Reference Number: DA21/0675 File No: D/2021/0675
[REDACTED]

RE: Submission for Objection to proposed alterations and additions to 67 Coleman St, Wagga Wagga NSW 2650 – DA21/0675 – Lot 1 DP743340

Figure 1: Extract from Shadow Diagram
(Source: Sewell Designs)

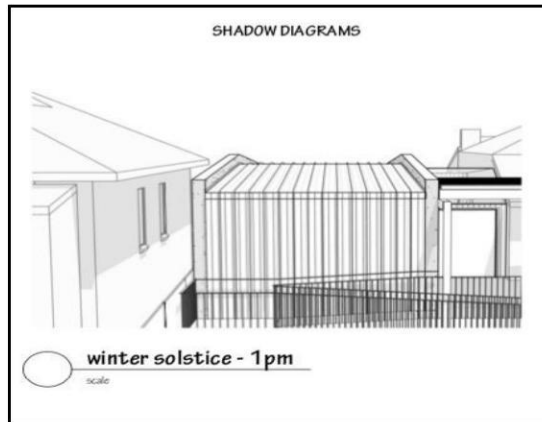
The proposal seeks to place a long blank wall along the boundary of the western side [REDACTED]
[REDACTED], limiting solar access. The shadow diagrams provided did not account for the awnings currently in place on the windows on the western wall [REDACTED], [REDACTED] meant to remove these awnings so as to be able to access sunlight at [REDACTED] own cost? [REDACTED]

[REDACTED] Amended plans should be submitted by Sewell Designs which incorporate [REDACTED] awnings and show the shadow diagrams correctly incorporating this. [REDACTED]

[REDACTED]. We also wish to note that drawings submitted in the plan set propose night dining at 67 Coleman Street which currently isn't approved. Please see photos below:
